COMMUNITY DEVELOPMENT DEPARTMENT REPORT

SUBJECT: H-2025-0006
Mogul Industrial Park Subdivision

LOCATION: Generally located at the northwest corner of Black Cat Road and I-84 (Parcels: S1216141821 and S1216131201) in the east half of section 16, T.3N., R.1W.

Preliminary plat to subdivide two (2) existing parcels into eleven (11) building lots in the I-L zoning district on 88.20 acres of land.

C. Site Plan (date: 4/29/2025)

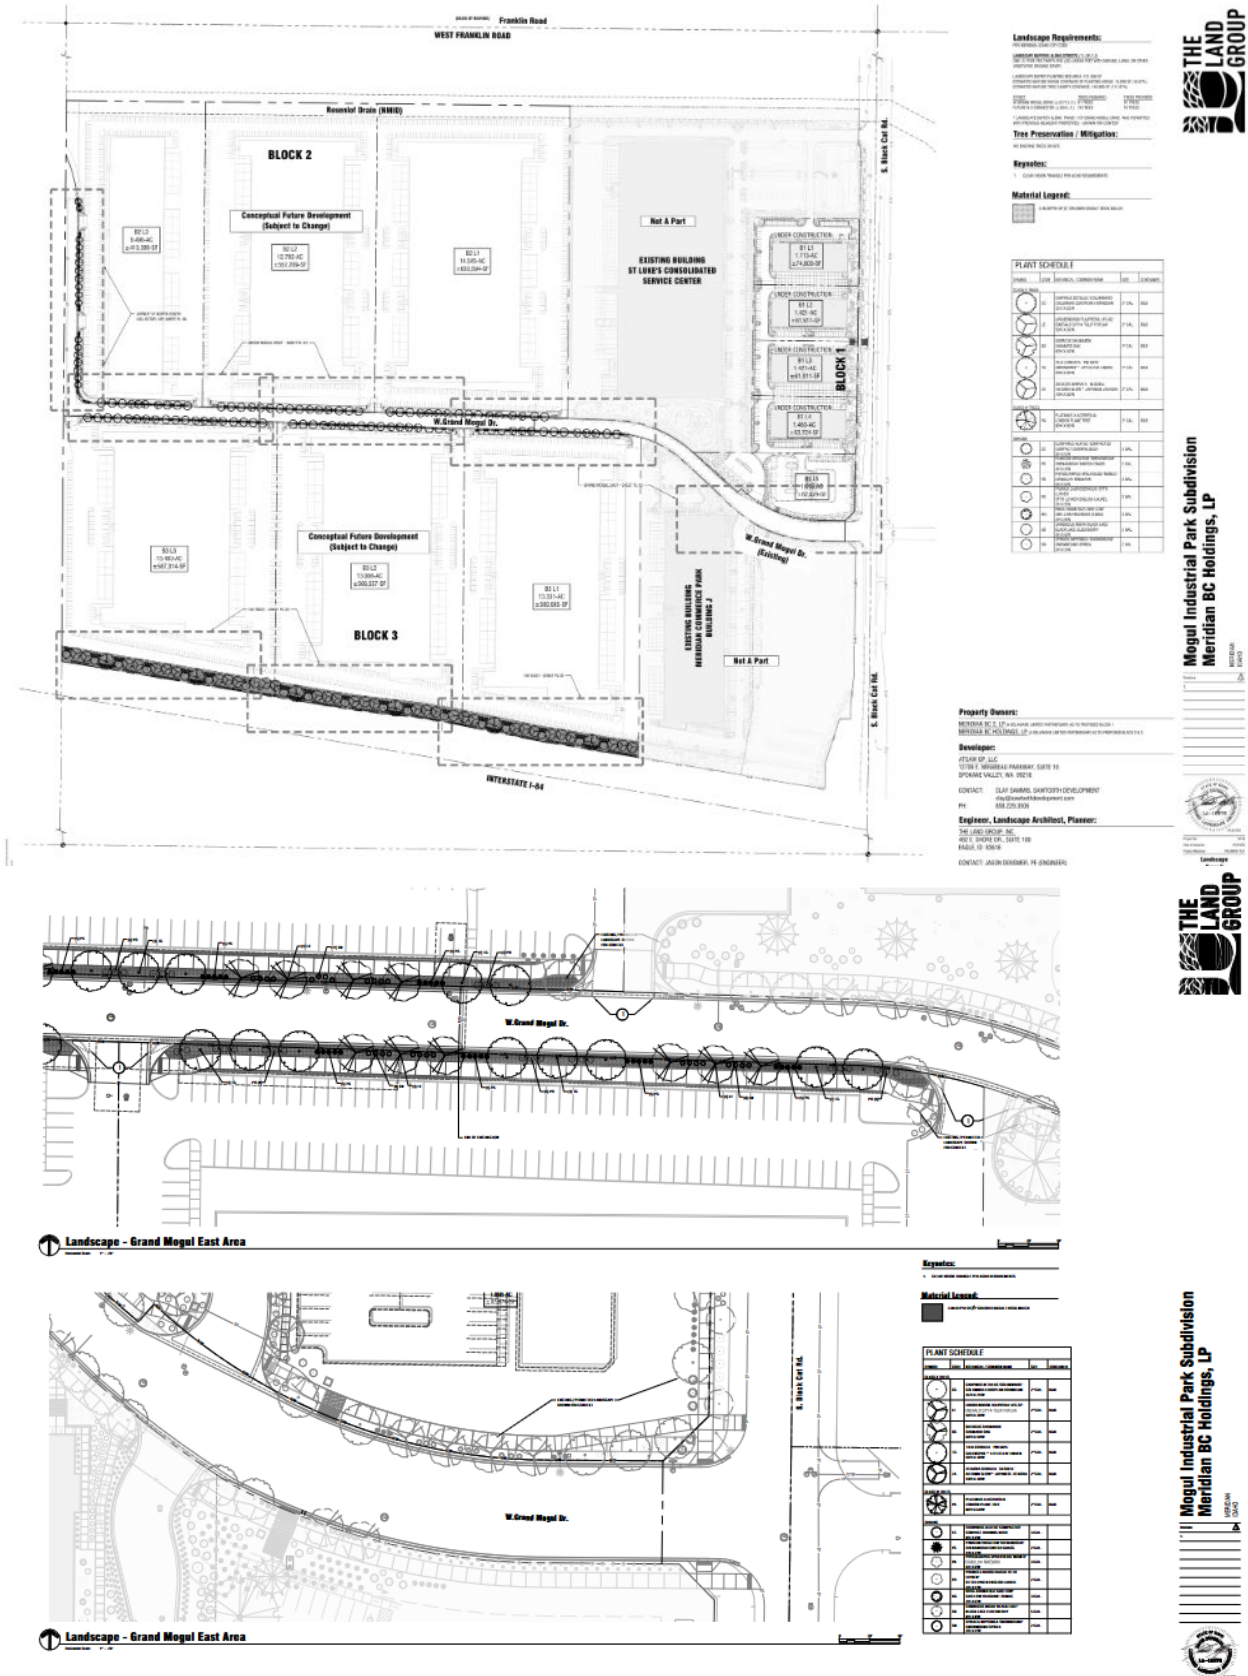
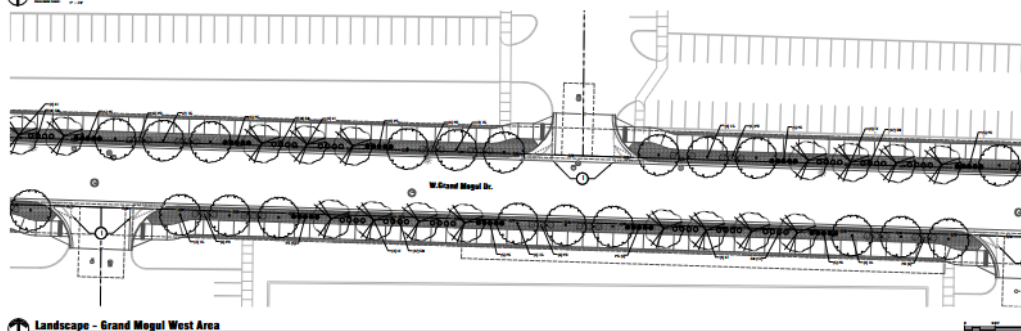
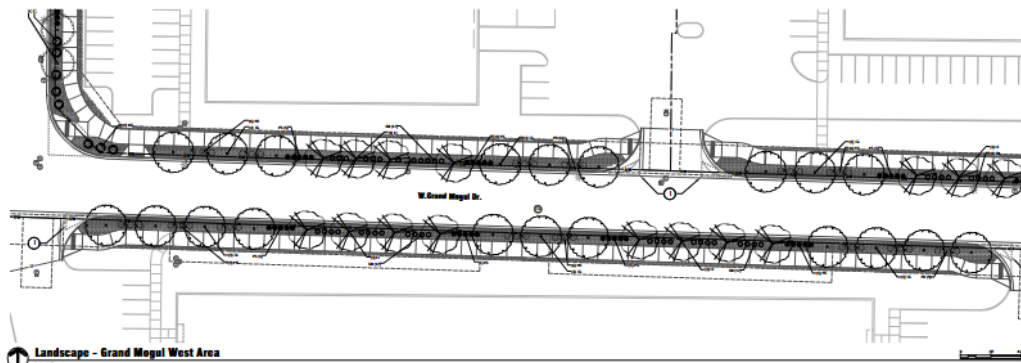
However, staff has concerns with the proposed alignment of the north/south collector road, as it currently does not extend to the northern boundary of the development. While the applicant has provided an exhibit illustrating how the road could potentially be extended in the future, ultimately connecting to Franklin Road further north, staff believes the alignment should be reconsidered.

Long-range planning efforts, in coordination with ACHD, may lead to a more logical connection to Franklin consistent with the Master Street Map (MSM). Staff recommends shifting the roadway alignment farther to the east on the property, stubbing it at the northern boundary, and aligning it near the eastern edge of the Rosenlof Drain as it heads toward Franklin. This alignment may facilitate a four-legged intersection at Franklin and provide improved access for this property and properties north of the site and east of the Rosenlof Drain.

In addition, the MSM anticipates an east/west collector north of the subject development. This planned road would provide access to this site independently of the adjacent property to the west, which may not develop for some time due to limited sewer access. *Note: While ACHD has approved the street alignment as proposed by the applicant, staff recommends a shift eastward to better align with long-range connectivity goals. This would also require a significant redesign of the plat.*

2. **Fifteen (15) days prior to the City Council hearing, the applicant shall submit a revised preliminary plat that shifts the north/south collector road farther to the east and stubs to the north boundary of the Rosenlof Drain and coordinate with ACHD on the requirements for the crossing over the drain.**

3. The final plat shall be revised as follows:
 - a. Depict street sections for W. Grand Mogul Drive and the future north/south collector consistent with Street Section C in the TMISAP with a modification that allows for 8-foot parkways and detached 10-foot wide sidewalks/pathways in lieu of on-street bike lanes as required TMISAP. Streetlights are required at a pedestrian scale (see pg. 3-20, 3-22, 3-23).

- c. Revise the plat and landscape plans to accurately depict the dimensions of the landscape buffers along W. Grand Mogul Drive and north/south collector road (20-foot wide), S. Black Cat Road (25-foot wide), and I-84 (50-foot wide) on the plans.

- d. Add a plat note stating a blanket cross-access easement encumbers all lots within the subdivision and add a note that references the recorded CCR's in effect for the development.

D. Landscape Plan (date: 4/29/2025)

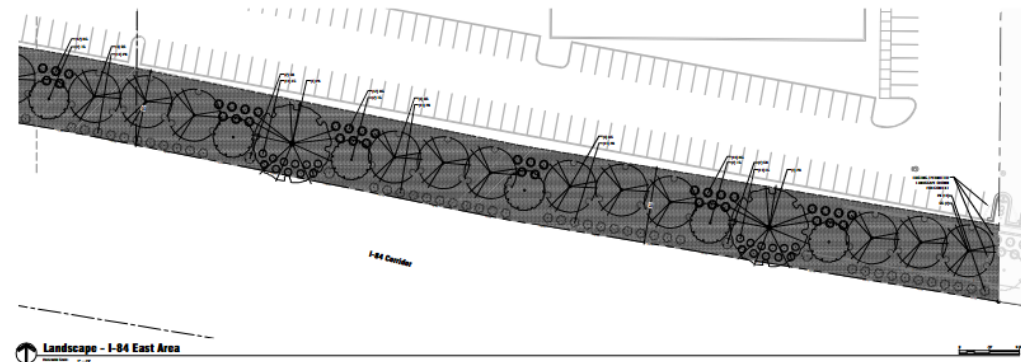
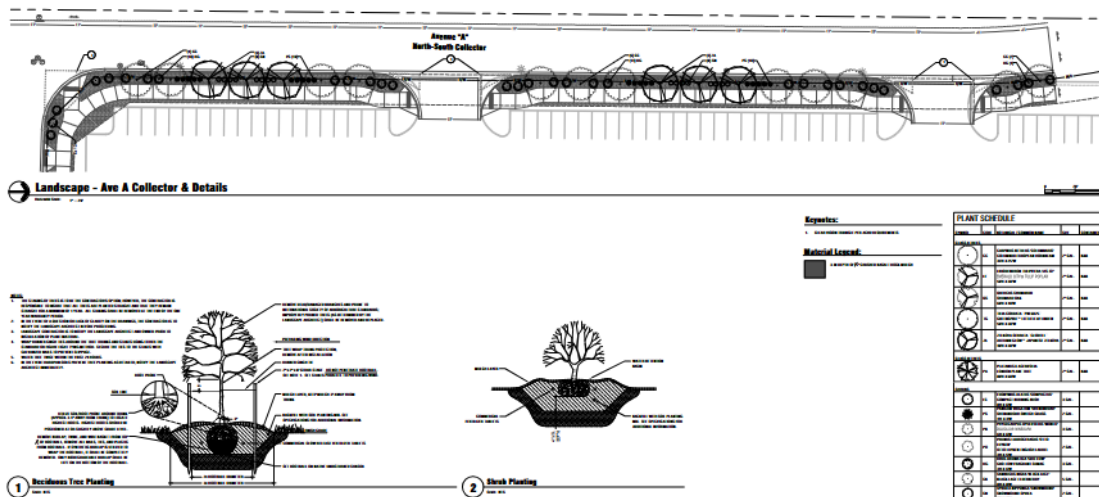
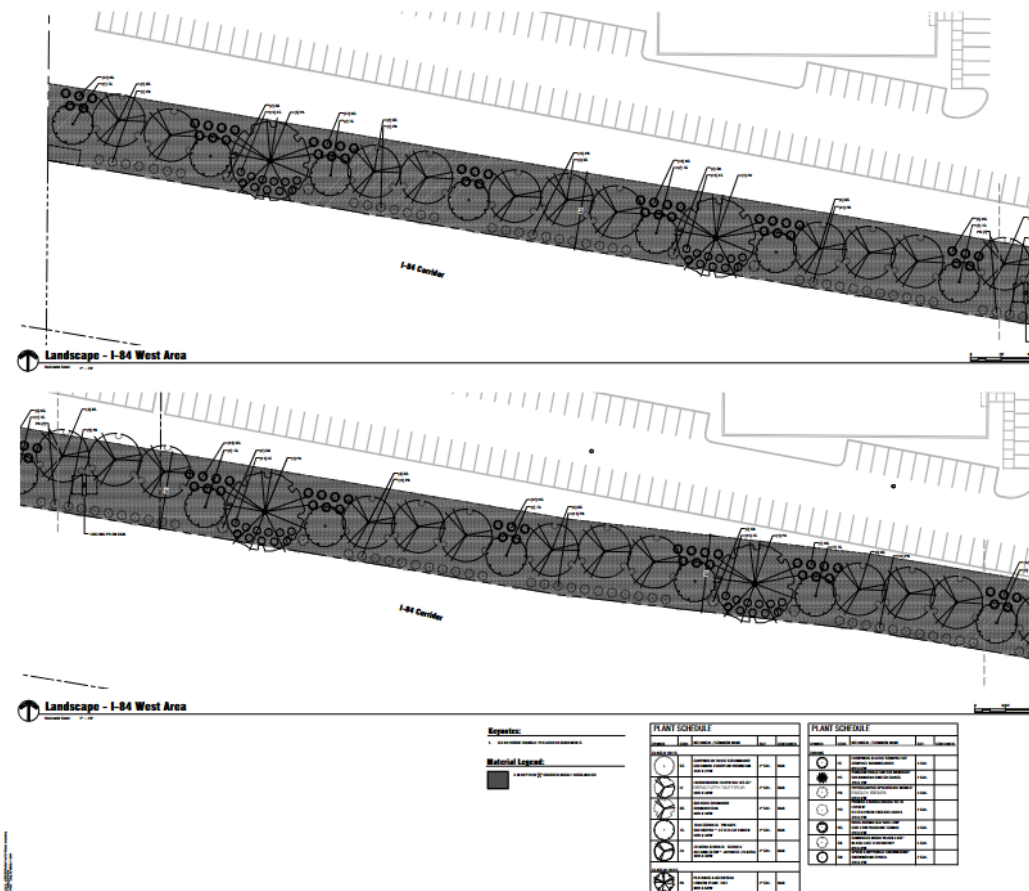
4. The landscape plan shall be revised as follows:
 - a. Revise the plat and landscape plans to accurately depict the dimensions of the landscape buffers along W. Grand Mogul Drive and the north/south collector road (20-foot wide), S. Black Cat Road (25-foot wide) and I-84 (50-foot wide) on the plans; currently both landscape buffers do not accurately depict the landscaping as required by UDC Table 11-2B-3.

- b. Depict landscaping within required street buffers in accord with standards listed in UDC 11-3B-7C; all required landscape buffers along streets shall be designed and planted with a variety of trees, shrubs, lawn, or other vegetative ground cover. Plant materials in conjunction with site design shall elicit design principles including rhythm, repetition, balance, and focal elements.

- c. Revise the plat and landscape plans to include the dimensions of the pathways.
 - d. Depict landscaping along all pathways per the standards in UDC 11-3B-12C. A 5' wide landscape strip is required on both sides of the pathway planted with a *mix* of trees, shrubs, lawn and/or other vegetative ground cover.
